Master File #: MLP-2019-003 ^{VR-2019-011}

Request: A two-parcel Partition, a Type II Variance to a side yard setback, and a Type I Minor Modification to an existing conditional use.

DATE: October 21, 2019
TO: Vera Kolas, Associate Planner, City of Milwaukie
FROM: Debbie Cleek, Senior Planner
SUBJECT: RESPONSE TO THE INCOMPLETENESS LETTER (MLP-2019-003 – 2889 SE Hillside Ct)

PRELIMINARY PARTITION PLAT

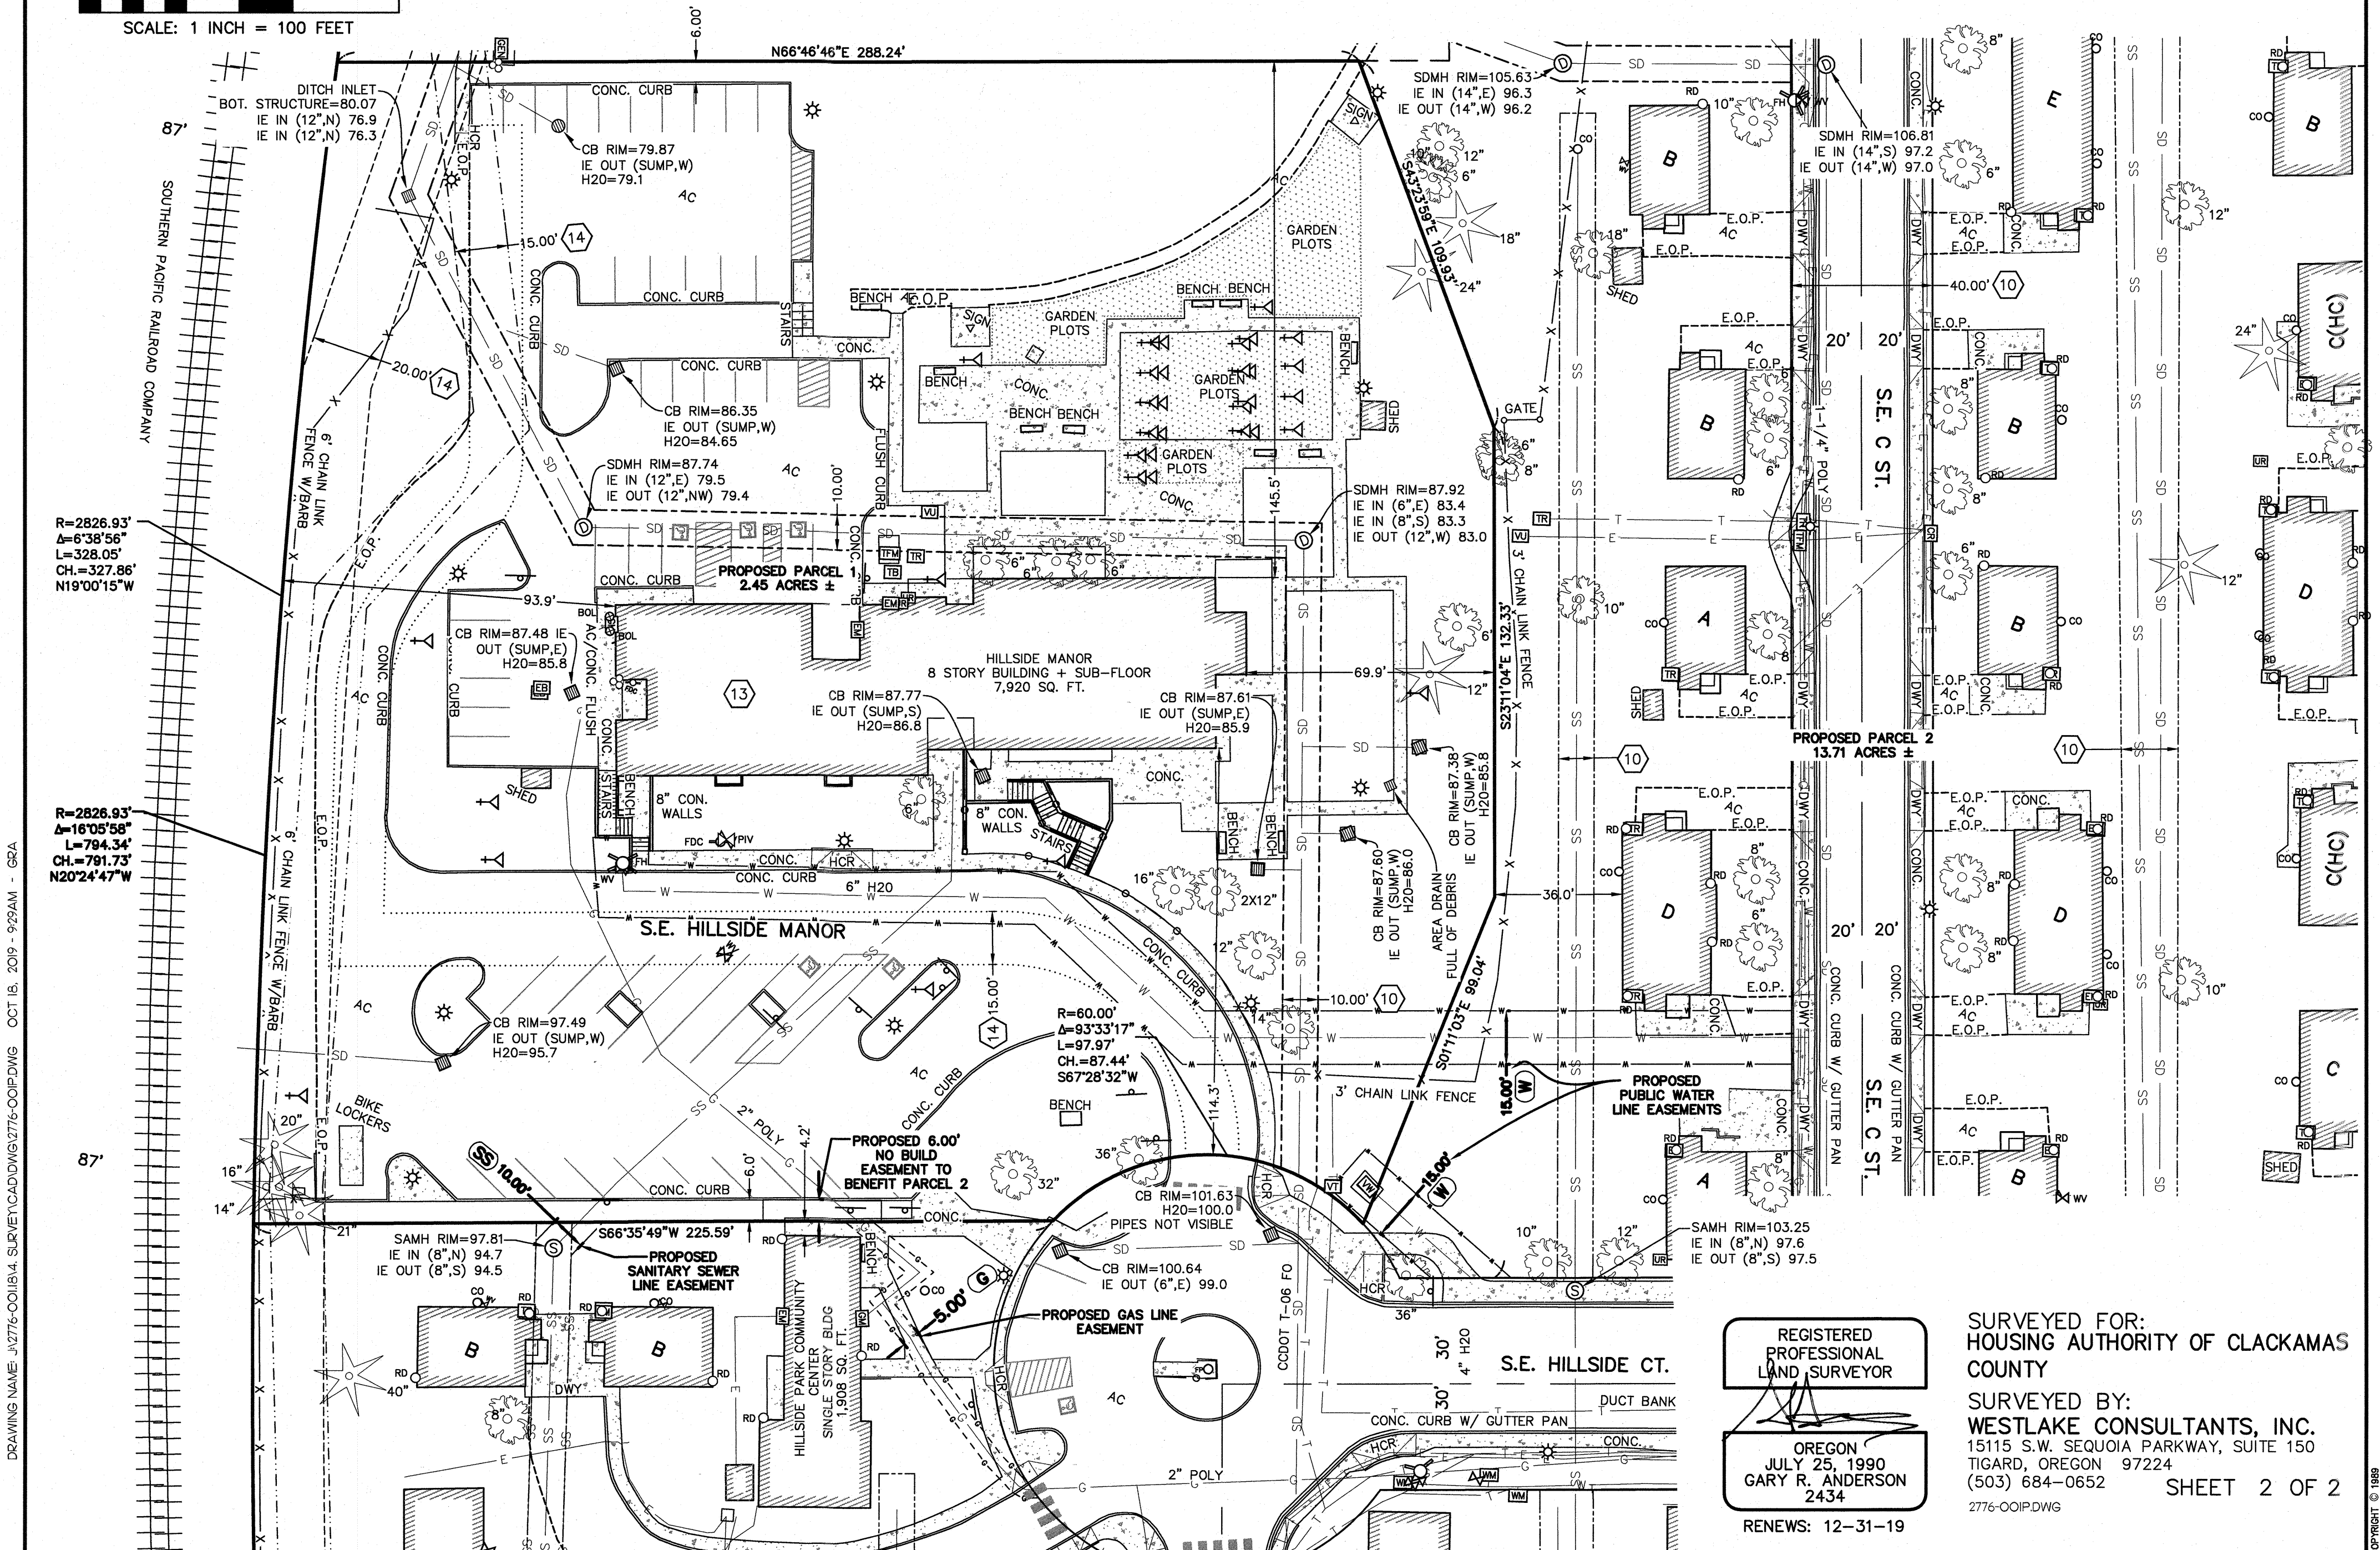
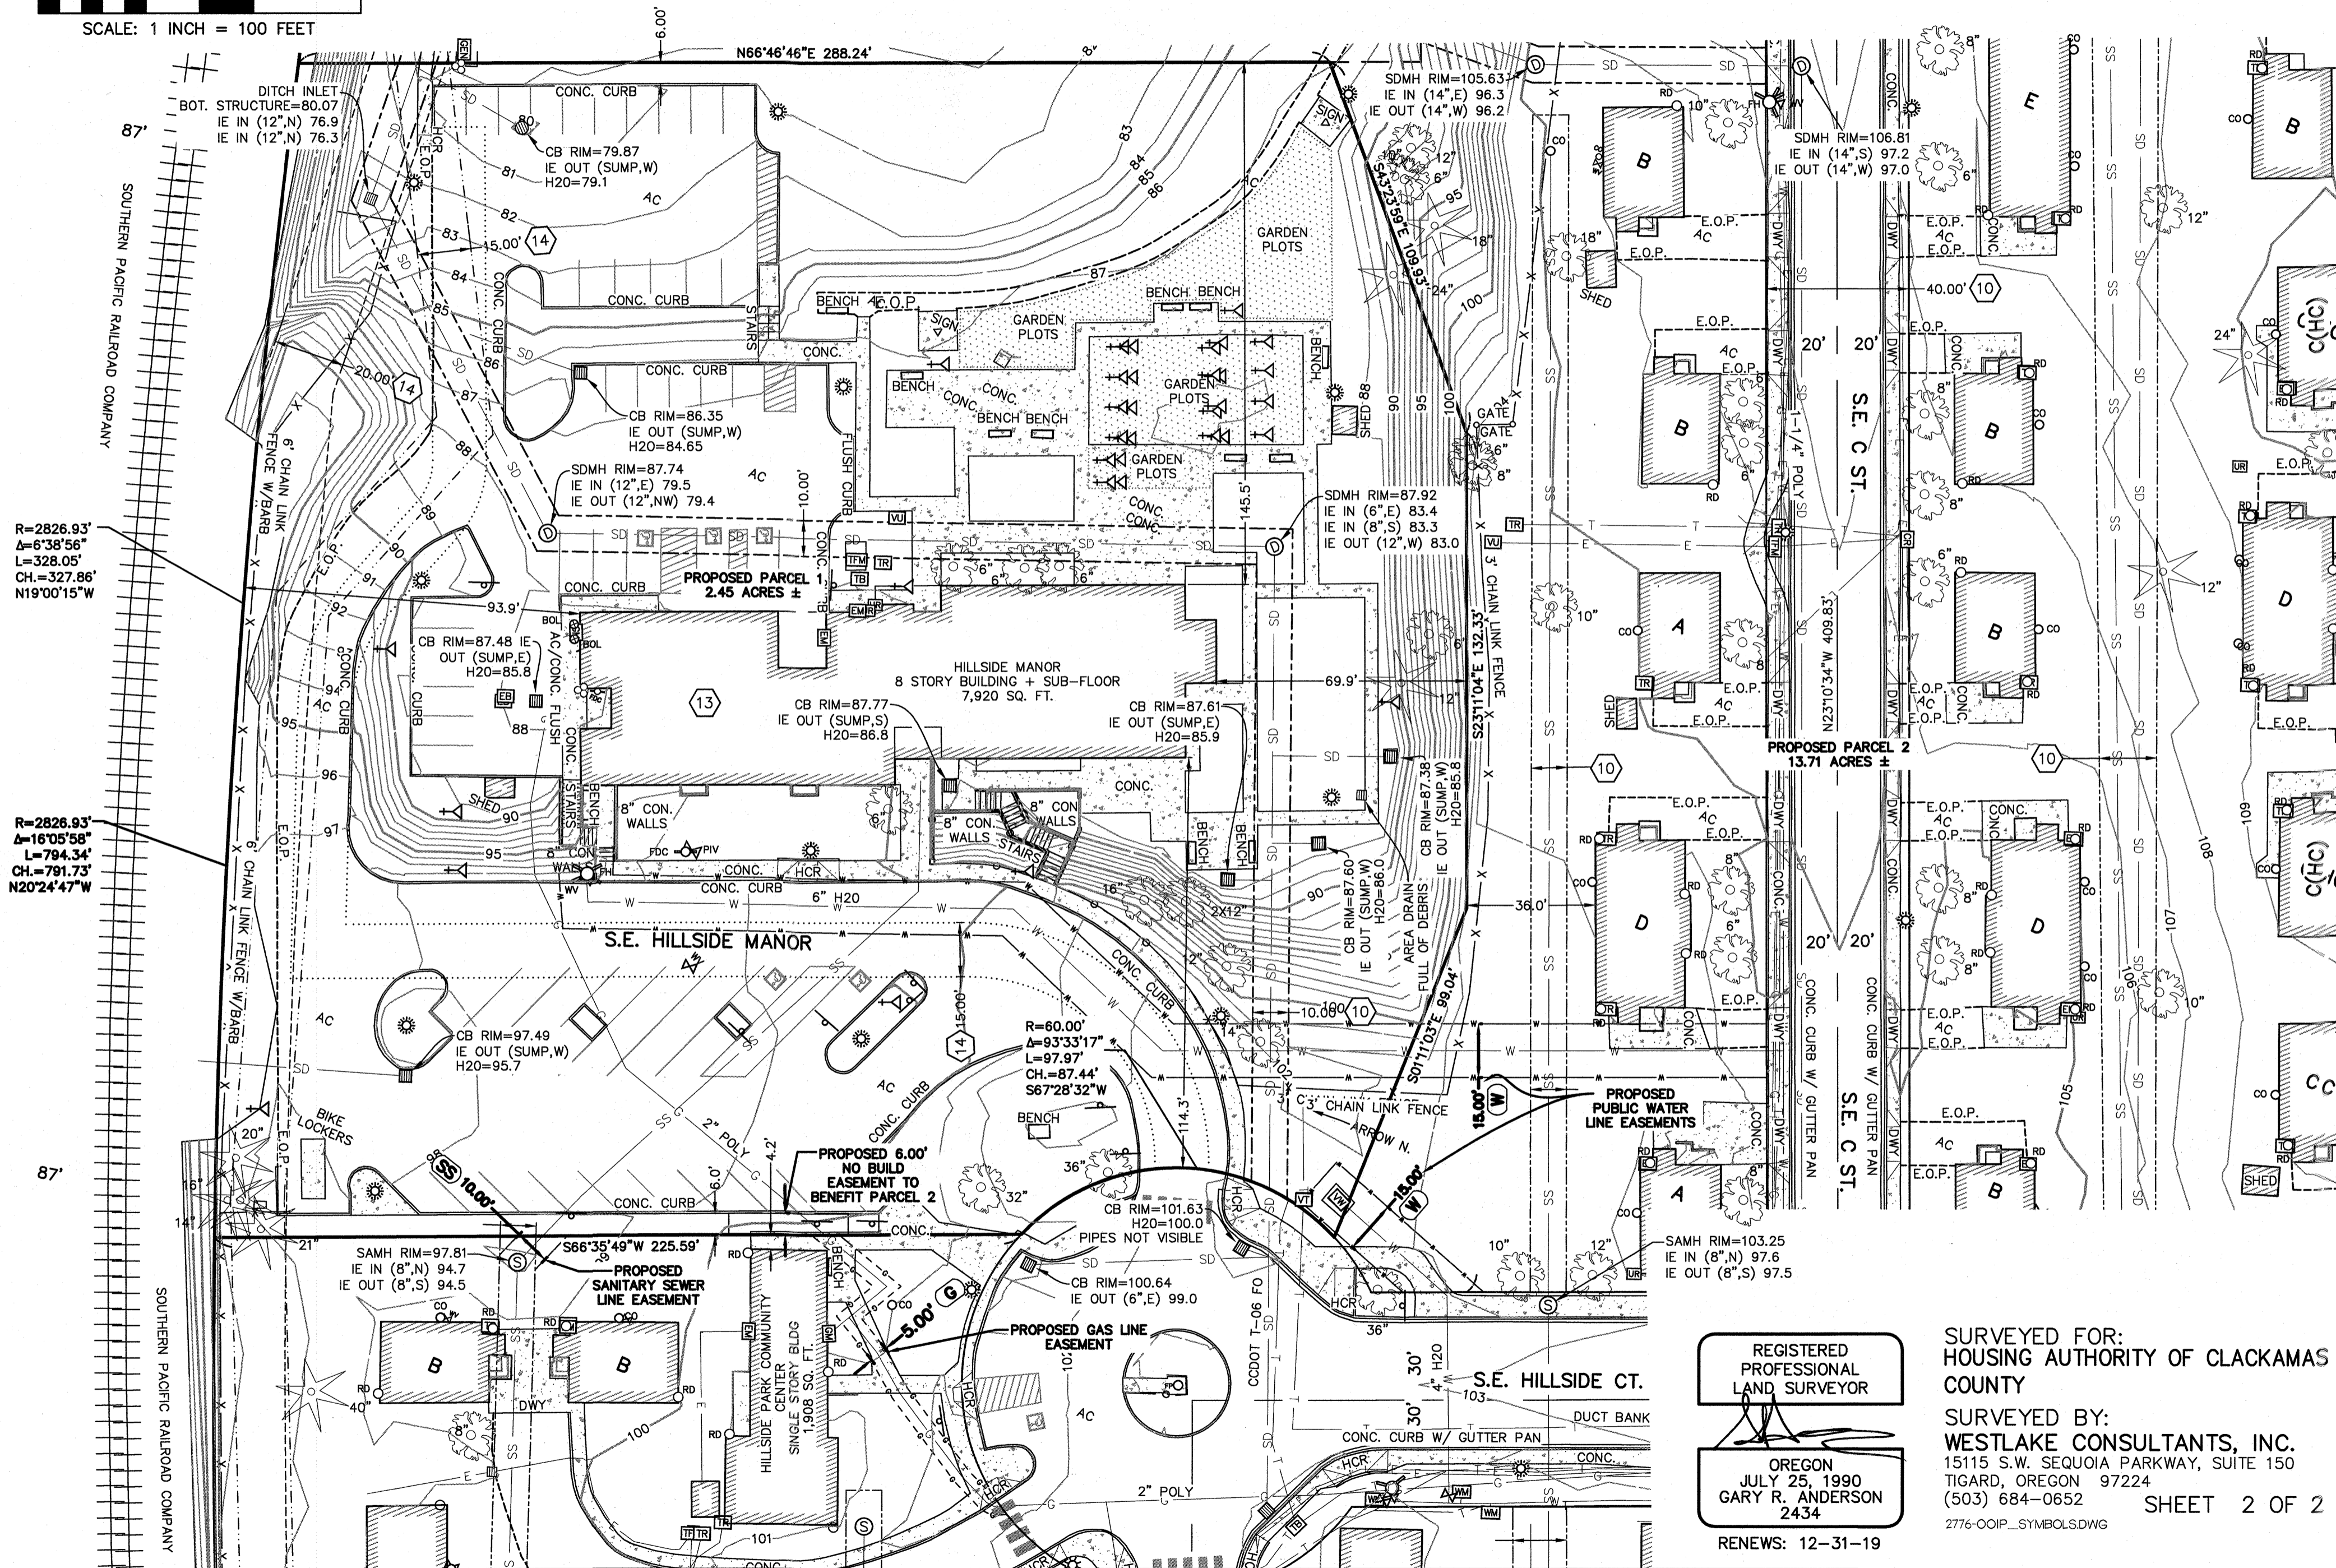
- a. *Show the public water easement for all public water lines located on Parcel 1, identified in Attachment 1. Easements must be 15 ft wide.*

3. *The proposed water line easement to the benefit of Parcel 2, as shown on the preliminary plat, is not required. This is a public water main, and the easements on Parcel 2 will change with the future development of Parcel 2.*

Response: Two proposed Public Water Line easements have been added to the proposed partition plat. One covers the public water line that connects Hillside Manor to the water line in C Street. The second covers the short public water line that runs north from Hillside Court to an existing water line.

Response: The private water line easement has been removed from the plat, in lieu of the new public water line easements.
